# Safety Recall Trucks

Date	Group.	No.	Page
06.11	SC0350		1(4)

Power Mirror Switch Failure

MRU

1 - 21665322, Jumper harness

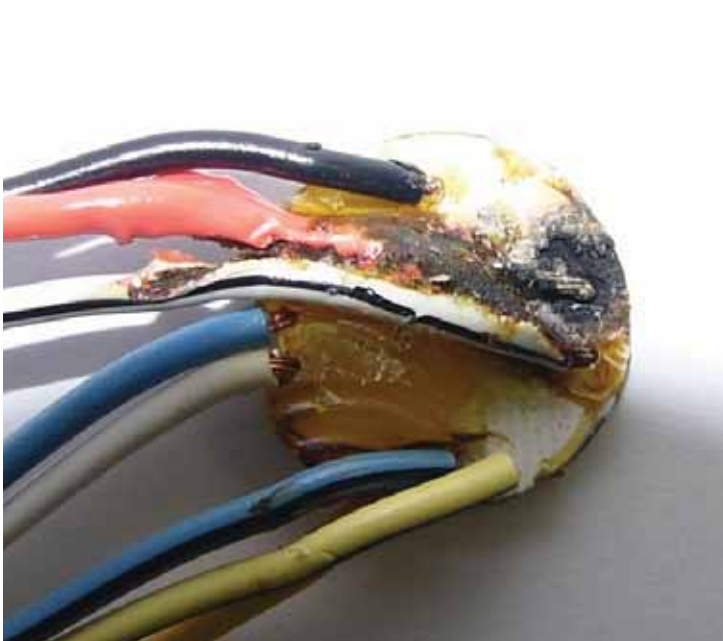
Certain MRU model chassis may experience a failure resulting in inoperative power mirror functions or melting of the switch under current load situations.

4. Locate the relays mounted under the back glass on the rear of the cab. Install the relay portion of the harness into position with the cable outlet side down.

5. Lay harness into position and route towards the mirror switch located on the switch panel. Disconnect the mirror switch and connect the new harness between the switch and cab harness.
